Dublin City Cycle Scheme "dublinbikes"

Stage 3 Road Safety Audit

November 2009

2.21 Site 21 (22A) Leinster Street South

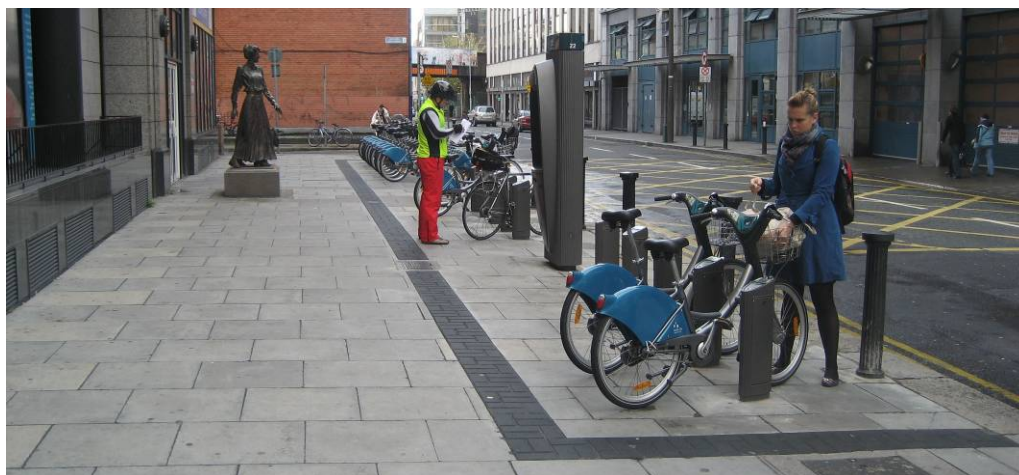
The kerb build-out and 500mm buffer zone adjacent to the cycle station has resulted in a reduction of the width of the adjacent road carriageway. No carriageway lane markings are provided to delineate the two eastbound traffic lanes. There is a risk that eastbound vehicles, while vying for road space, may inadvertently strike a cyclist withdrawing a bicycle from the station.

Lane marking should be provided on the carriageway adjacent to the cycle station to promote good lane discipline.

Site 35 (35C) Smithfield

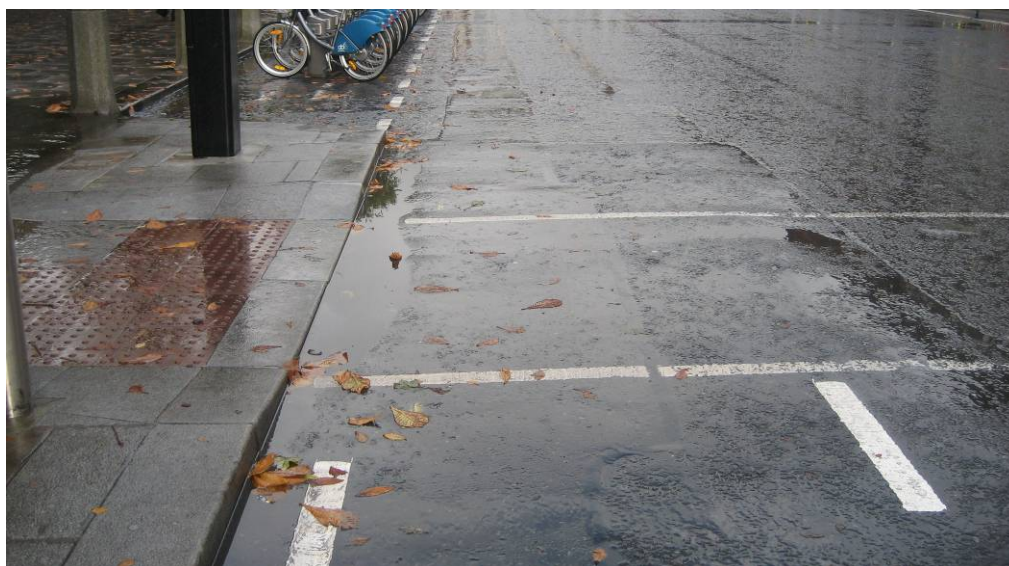
The cycle station, in particular the station bourne, was observed to be dimly lit at night time. Poor public lighting in this location could lead to personal security and safety issues at night time.

Carry out a public lighting assessment at the station and consider the provision of additional public lighting at the station if deemed necessary.
